Council reference: DA11/0565.12  
Your reference: MP08\_0194 MOD 15

**Major Projects – New Request for Advice - MOD 15 - Split building, allow 24hrs, and other changes to Precinct 1 (MP08\_0194-Mod-15) (Tweed Shire)**

Thank you for the opportunity to provide comment on the proposed changes to Kings Forest Project Approval MP08\_0194 as it relates to Precinct 1 – Service station and Food & drinks premises – MOD 15.

Figure 1- Extract from Drg DA-2001- P5 Western Elevation – Push Architecture

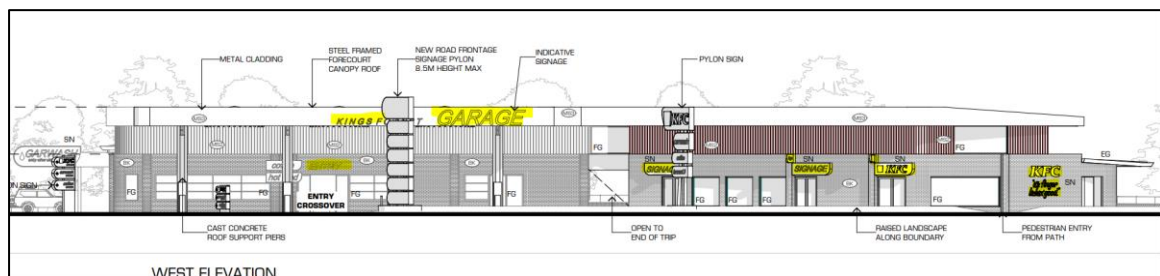
In relation to Item 13, it is noted that Condition A12 of the consent specifies that MP08\_0194 does not give approval to retail fit out, or signage of the building in Precinct 1. Separate development approval/s consent for these matters must be obtained – Therefore while the current plans show signage on Buildings 1 and 2, these building signs cannot be considered under this application without modifying condition A12 – which it is not proposed to do).

Figure 2 – Comparison of Approved and Proposed site plan – Push Architecture

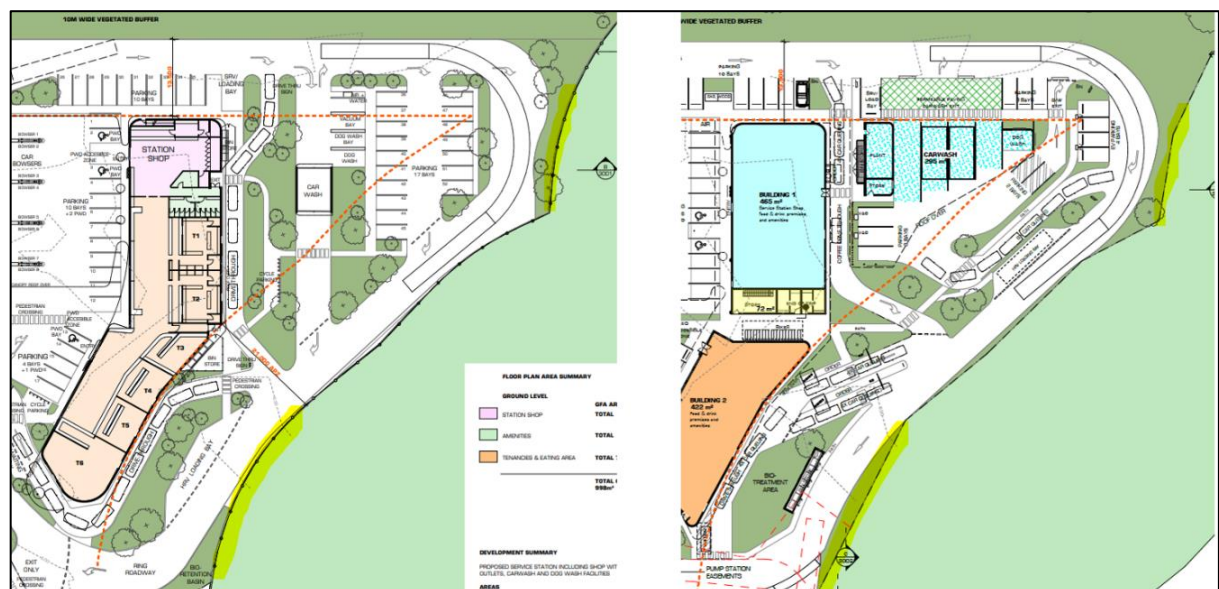
The proposed plans show a realignment of the fauna fence along the ecological buffer. It appears to show a slight reduction to the ecological buffer from the approved plans (see yellow highlights below) however the revised plans also appear to align with the current property boundary. This should be confirmed.

Figure 3 – Extract from Site plan Drg DA0002 – P11 – Push Architecture

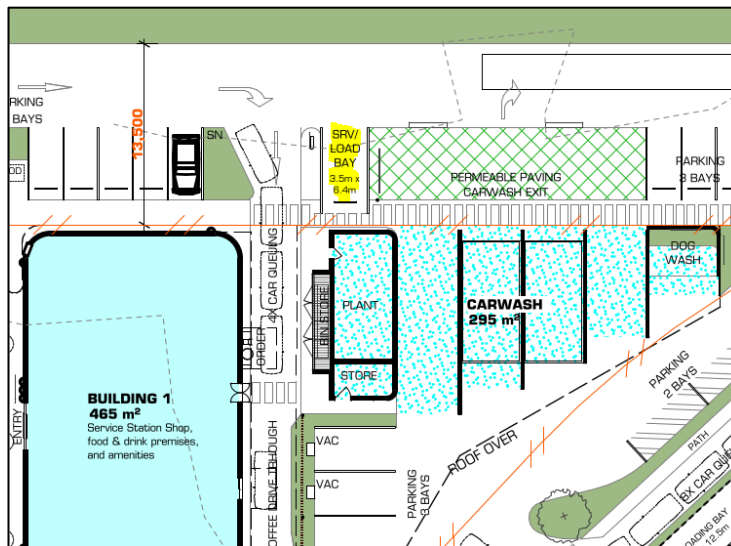
- This loading bay remains significantly smaller than the previous SRV / Loading bay.
- The proposed bay is also in an isolated location and it is questioned as to what it is servicing? It appears that the loading bay will require use of the pedestrian footpaths which may cause conflict with others users

Figure 4 – Extract from Site plan Drg DA0002 – P11 – Push Architecture

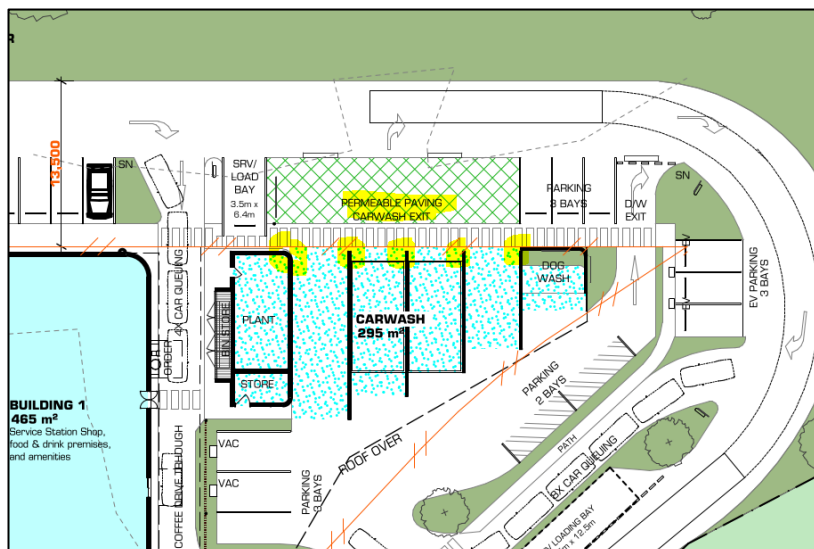
- It appears that the intent is for users of the car wash is to drive over the pedestrian footpath and then over the permeable pavers to exit. This raises concerns with potential pedestrian safety and conflict of use.
- It appears that Sight Line triangles (no different to a driveway) are not provided for existing vehicles from the car wash bays, putting pedestrians safety at risk.
- It should be noted that permeable pavers effectiveness deteriorate unless maintenance is undertaken.

Figure 5– Extract from Site plan Drg DA0002 – P11 – Push Architecture

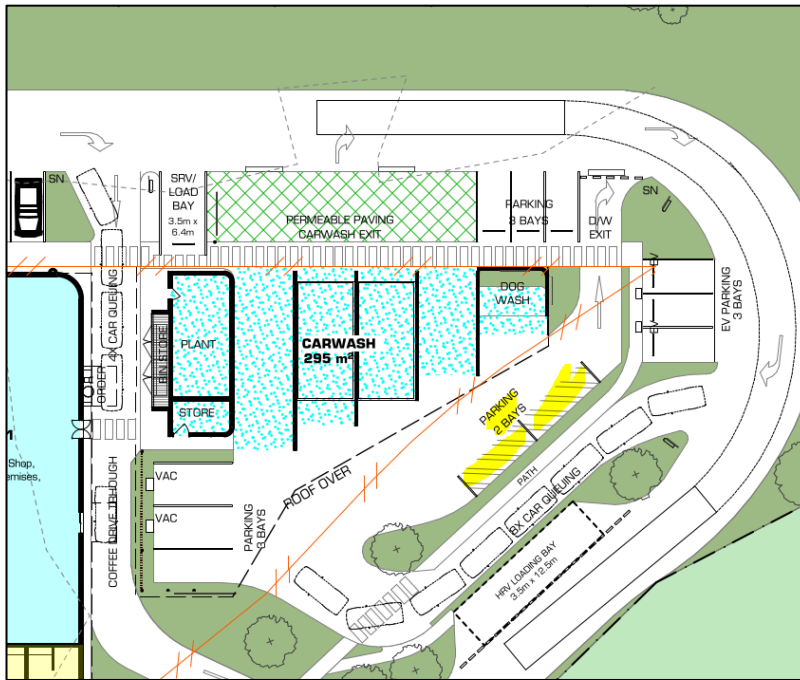
- These 2 parking bays have potentially to impact on vehicles exiting the car wash area.
- They appear to be in an inappropriate location.

Figure 6 – Extract from Site plan Drg DA0002 – P11 – Push Architecture

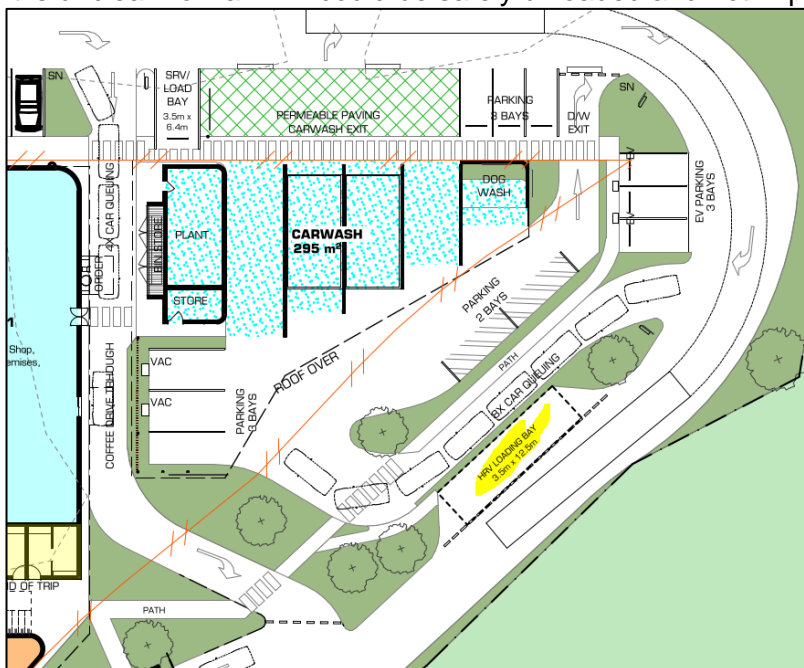
- Similar to the SRV (above), the proposed HRV bay is in an isolated location and it is questionable as to what it is servicing?
- It is unclear how a HRV could be safely unloaded and not impact on exiting vehicles.

Figure 8 – Extract from Revised Conceptual Stormwater Report – Proposed Stormwater Management Strategy

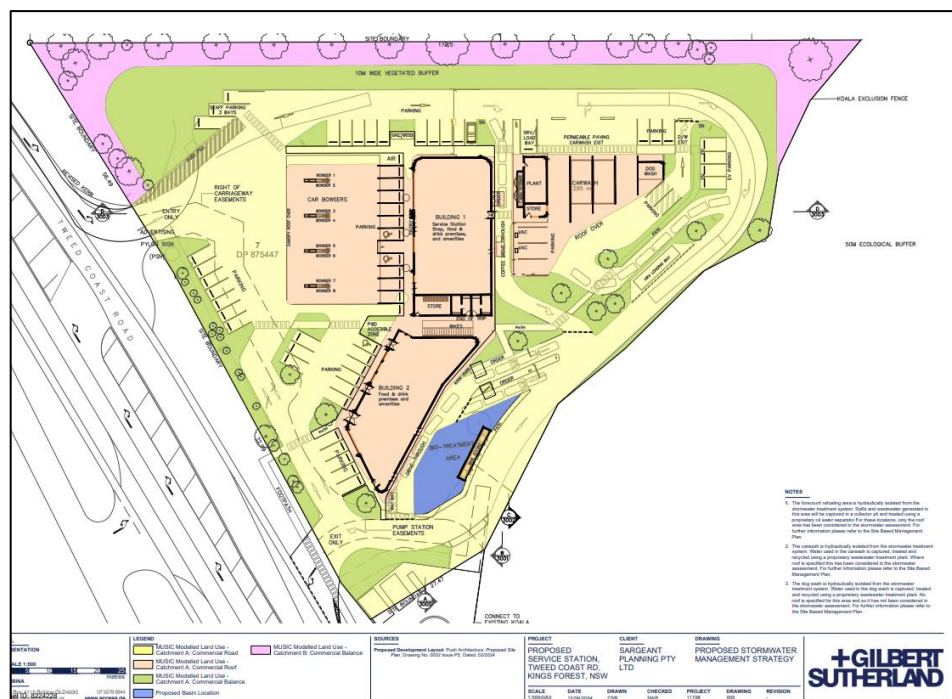
The 'Revised Conceptual Stormwater Assessment' prepared by Gilbert & Sutherland presents MUSIC modelling results which demonstrate the pollution load reduction targets nominated in Development Design Specification D7 – Stormwater Quality are achieved for a bio-retention filter area of 140m<sup>2</sup>.

Figure 9 – Extracts from Revised Conceptual Stormwater Report

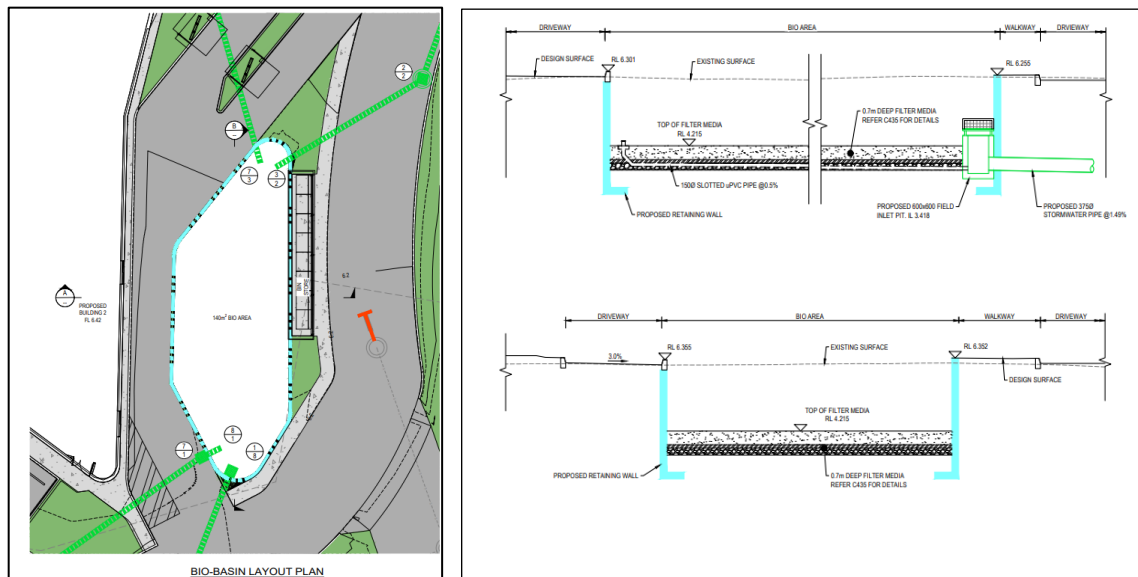
Safety fencing will be required around the future bio-retention basin. A 2.13m drop adjacent to walkways and driveways is detailed on the engineering drawings. – This can be managed by way of a condition.
